**Beatrice Offshore Windfarm  
Environmental Statement Addendum**

**Annex 9A Physical Processes  
Consultation Marine Scotland Science**

**BEATRICE OFFSHORE WIND FARM ENVIRONMENTAL STATEMENT:  
REPLY TO THE COMMENTS OF MARINE SCOTLAND SCIENCE**

**Annex 9B Physical Processes  
Consultation Surfers Against Sewage**

Figure 1. Scour Data for Wind Farms with No Scour Protection. From HR Wallingford *et al.* (2007).

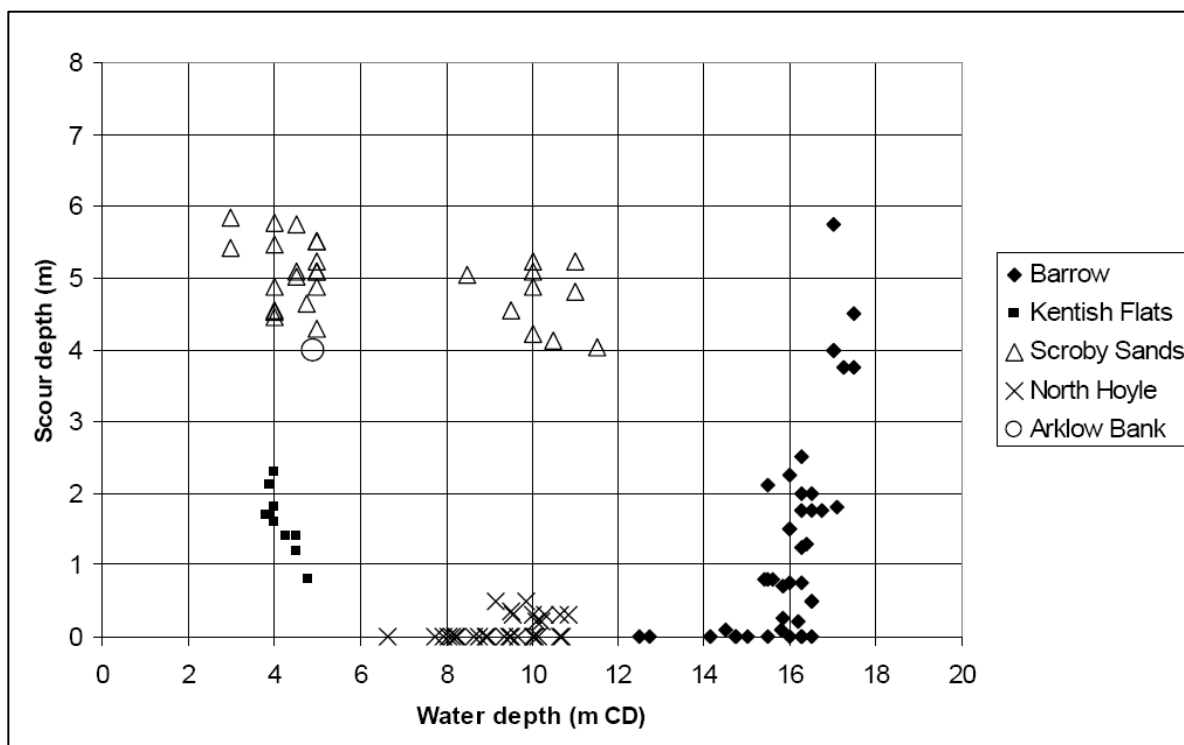
**Question 4: *What scour has been observed around the Beatrice wind turbines?***

The report provides a summary figure (Figure 1) of the observed individual depths of scour. It is noted that the values shown are from wind farms in the UK which:

- Do not use scour protection;
- Have used relatively slender (approximately 4 to 5m diameter) monopile foundations;
- Are in relatively shallower water depths (typically less than 10mLAT, up to 25 mLAT) compared to the Beatrice lease area (35 to 55 mLAT) and so are potentially more exposed to wave action.

Figure 1 indicates a wide degree of variability in the observed scour depth, both between and within sites. The maximum depth observed is however less than the maximum predicted depth (approximately 1.3 times the monopile diameter, as used in the present study). Local scour depths around the relatively smaller diameter corner posts of jacket foundations (e.g. the Beatrice Demonstrator) are estimated on

Differences in scour depth are primarily attributable to differences in seabed type. The seabed in North Hoyle and parts of Barrow wind farms appear more erosion resistant with little or no mobile sediment veneer. Kentish Flats and other parts of Barrow wind farm have an intermediate erosion resistance (or thickness of mobile sediment present). Scroby Sands and Arklow Bank wind farms are located in mobile sand bank environments and so exhibit the larger depths of scour.

Figure 1 shows that, in practice, scour depths are limited by the presence of erosion resistant soils (e.g. gravels, or consolidated clays) at some depth below the mobile sediment surface, the depth of scour being essentially limited to the thickness of the mobile sediment veneer. As such, a spatially varying limitation on scour depth (for unprotected foundations) would also be expected in parts of the Beatrice offshore wind farm due to the presence of erosion resistant tills in close proximity (within 0.5 m) to the seabed surface.

**1 – All Relevant Locations Considered?**

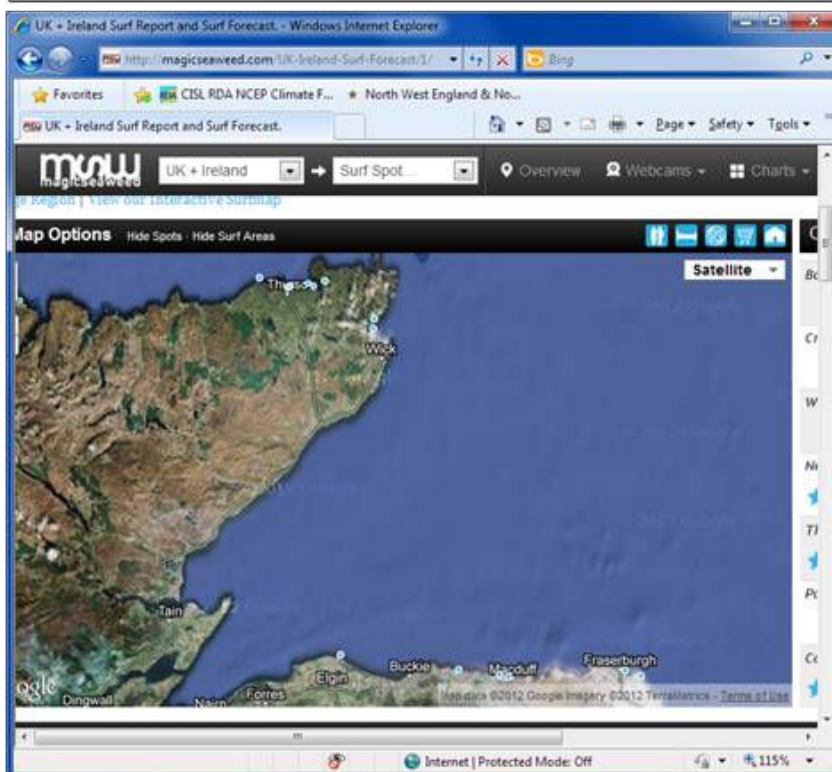
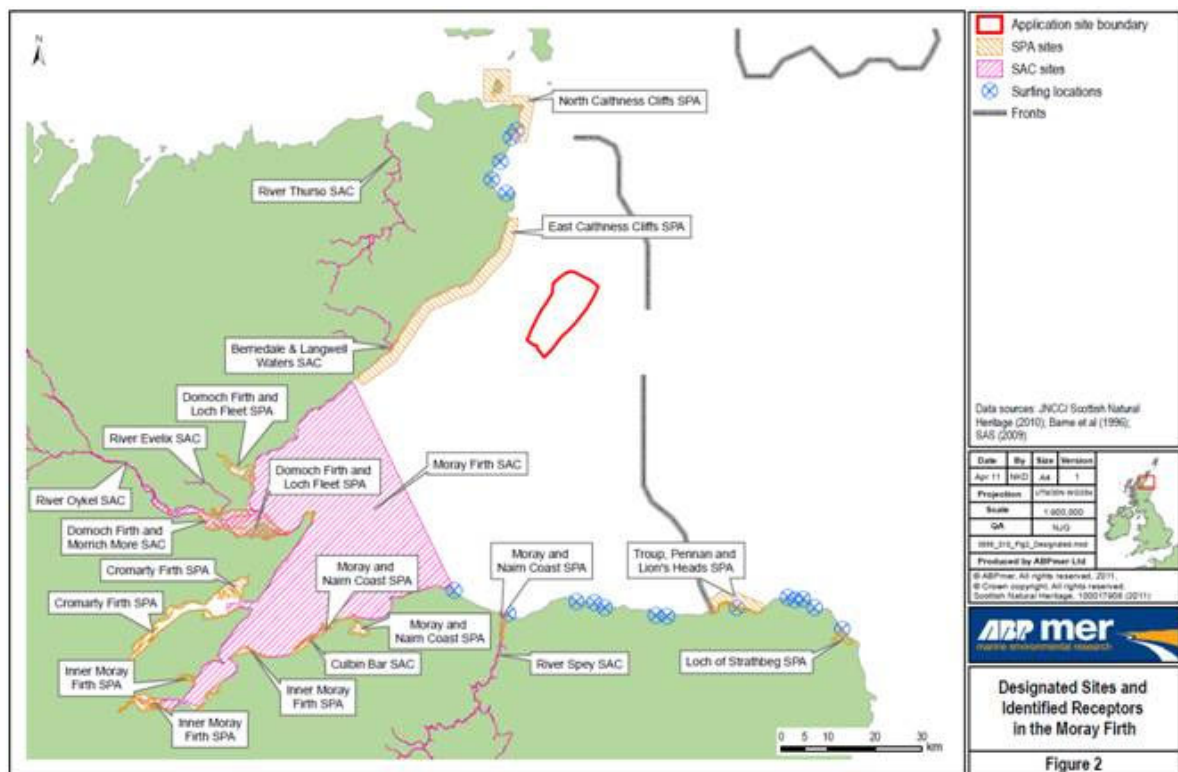
It is pleasing to see that you have considered the wave reduction height at each of the surfing locations considered. The list of 18 surfing locations seems to be satisfactory and represents the surfing locations used in the area. SAS are also waiting to hear back from the Scottish Surfing Federation (SSF) who will be able to confirm this. There is just one thing to clarify about the values stated in the ES for wave reduction: At 8 of the 18 locations considered, there is found to be a reduction of less than 0.01m wave height. At the remaining 10 venues, wave height reductions were generally limited to 0.01 – 0.02m, with a maximum of 0.04m at Cullen Bay. At which incident wave heights are these values calculated at? i.e. Are they at the most frequent wave height (0.5-1m) or are they at the most significant observed wave heights. As you can appreciate 0.04m reduction of a 0.5 wave is a nearly 10% reduction whereas 0.04m reduction of a 5m wave is more like 1%. If you could just clarify this point that would be great.

For reference, the figure [below left] shows the locations assessed in the ES (blue circles with crosses, as identified in the Stormrider Guide for Europe) and the figure [below right] shows surf spots presently highlighted on Magic Seaweed. The assessment provided in the ES is shown to include all of (and more than) the surf spots presently identified on Magic Seaweed.

Ideally, we would like to consider the above as a demonstration that all relevant locations have been assessed. If you agree, could we (provisionally) close this comment now?
